3. **Project# 1008878**
11DRB-70232 MAJOR – SITE DEVELOPMENT PLAN FOR BUILDING PERMIT

DEVELOPMENT REVIEW BOARD
Action Sheet

Attached are revised sheets (dated October 5th, 2011) for the Renal Medicine Associates Clinic at Journal Center 2, which was previously reviewed at your hearing on September 21st and deferred for your October 12th hearing.

Re: Site Plan Review
Renal Medicine Associates Clinic
Journal Center 2, Albuquerque, New Mexico
DRB# 1008838

Exhibit 1: Location of Nearest Adjacent Driveways

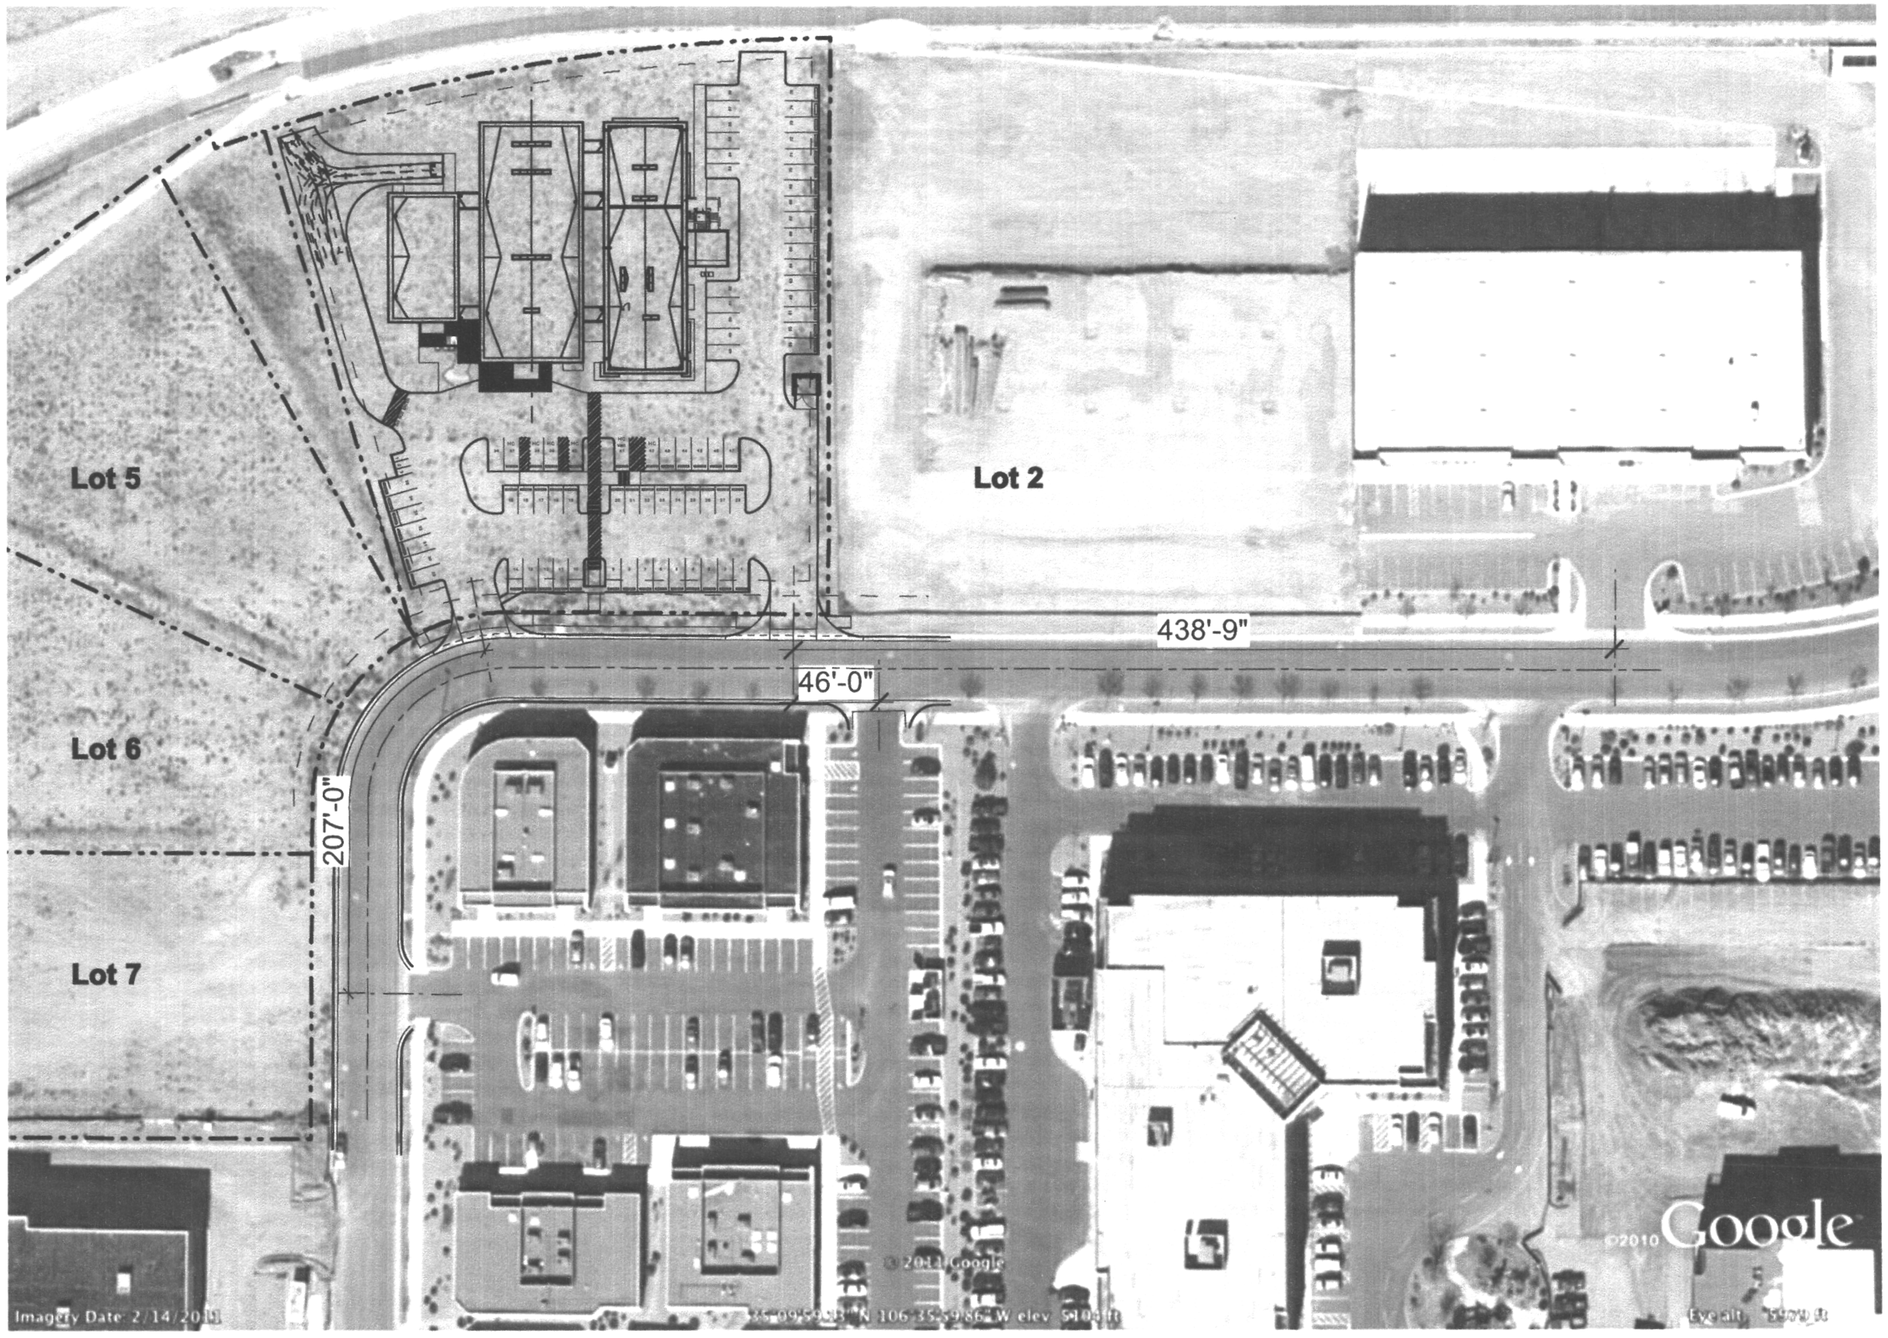
- The distance to curb cut / driveways on adjacent lots are indicated (please refer to provided Exhibit 1).
- As requested, the West entry drive to site has moved eastward, parking and planting areas have been modified accordingly.

AMBULANCE	feet
Width	: 7.71
Track	: 7.71
Lock to Lock Time	: 6.0
Steering Angle	: 47.8

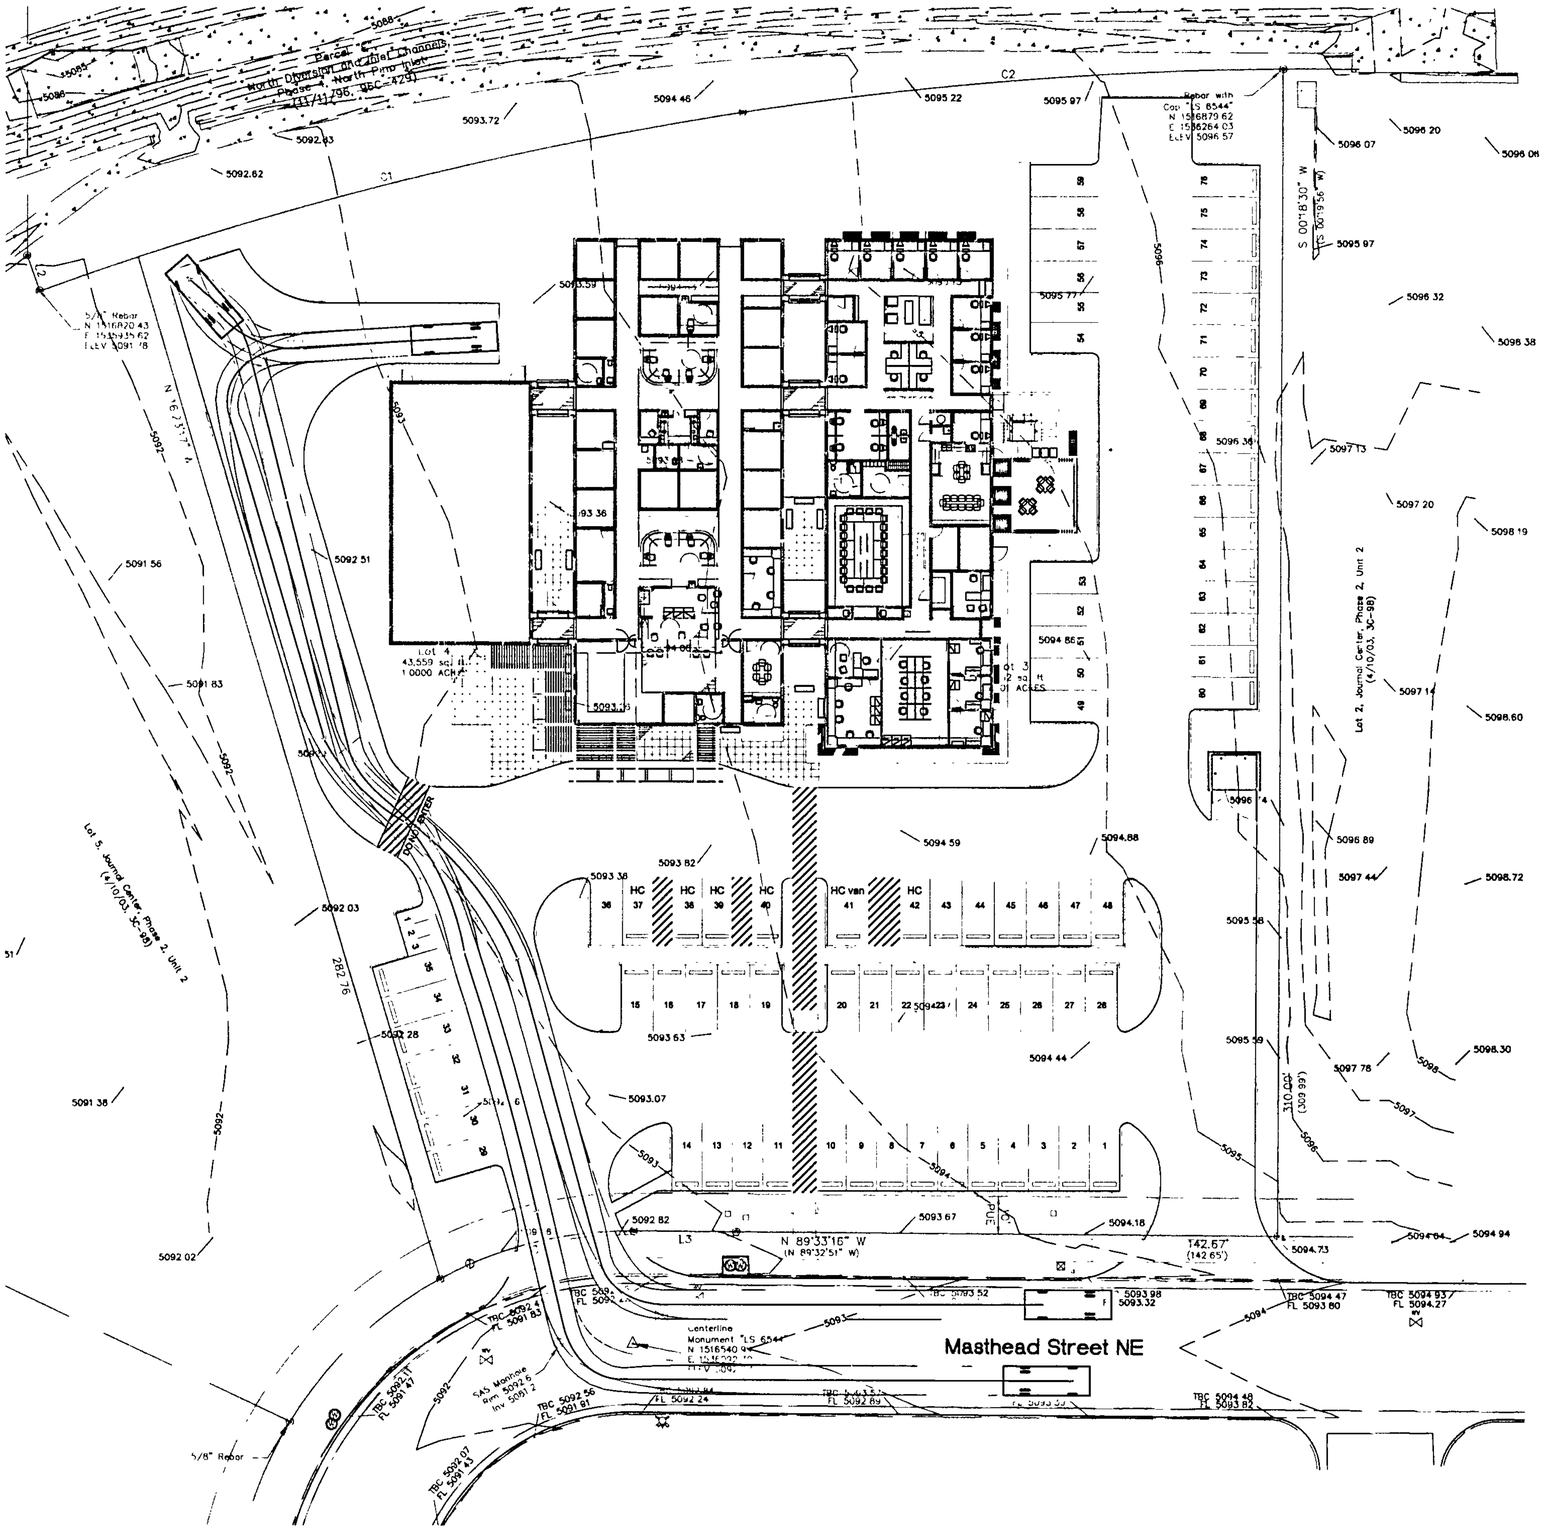
- Scale of drawing altered to conform with City Development Process Manual, at 1" = 20' scale.
- Verification that an ambulance and service vehicles will be able to access the service Entry at North side of Phase 2 (please refer to provided Exhibit - Ambulance Access). Service driveway left at 20' wide with signage stating "Service Vehicles Only" (see detail 5) and striping with painted "Do Not Enter" added to Site Plan.

1 A0.1 Site Plan
Scale: 1/16" = 1'-0"
0 8 16 24 32 FT

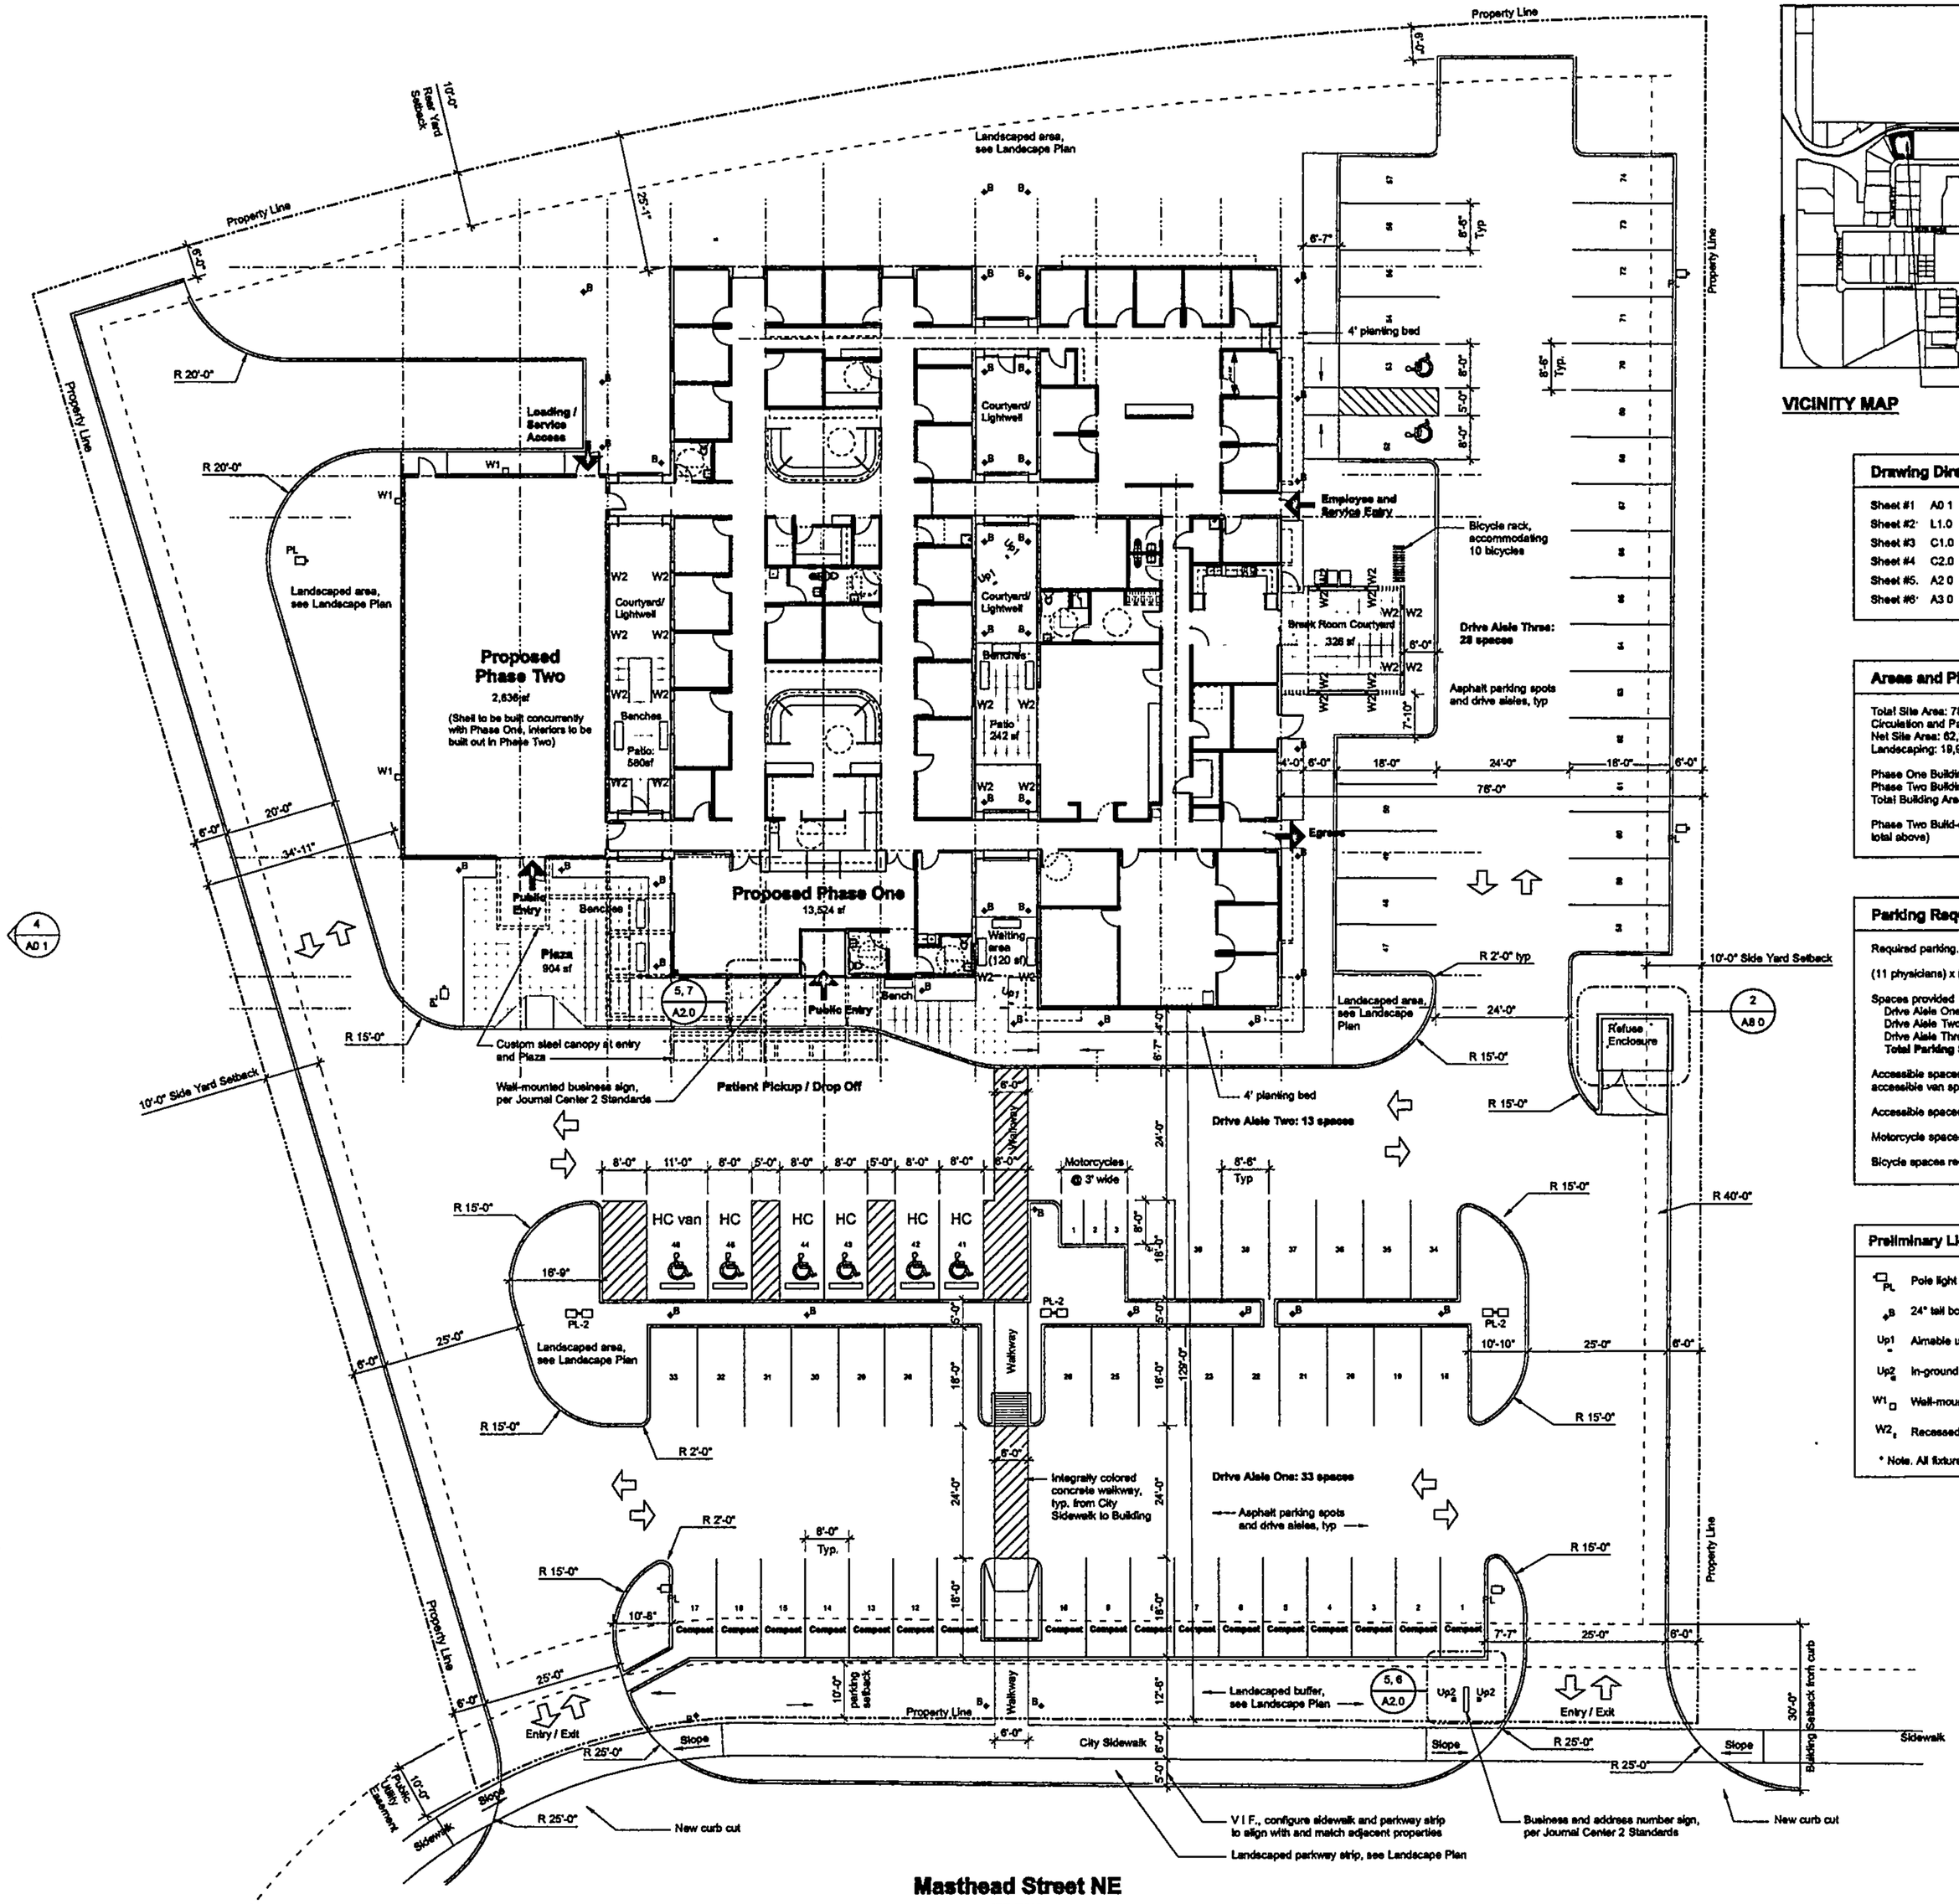
Refer to comments from Transportation Development regarding driveways – one ways are generally not acceptable with new development without extenuating design constraints.

- ADA Accessible pedestrian walkway provided at Accessible parking spaces, clearly noted. Width is 7'-0". All ramps shown. (Note, detail for bollard lighting at walkway not shown, as bollards have been removed).

- Details provided for all ramps.
- Build notes, referring to specific City Standards, have been provided at all items proposed in City Right of Way.
- All ramps located at City Right of Way will have truncated domes. (Please refer to drawing notes).

- Height of pole lights at parking lot modified to meet City Standard of 20' height.
- Side landscape buffers modified to provide 75% minimum vegetative ground cover.
- Disabled and motorcycle parking sign details shown.
- Rooftop mechanical units will be screened (please see note on Site Plan)
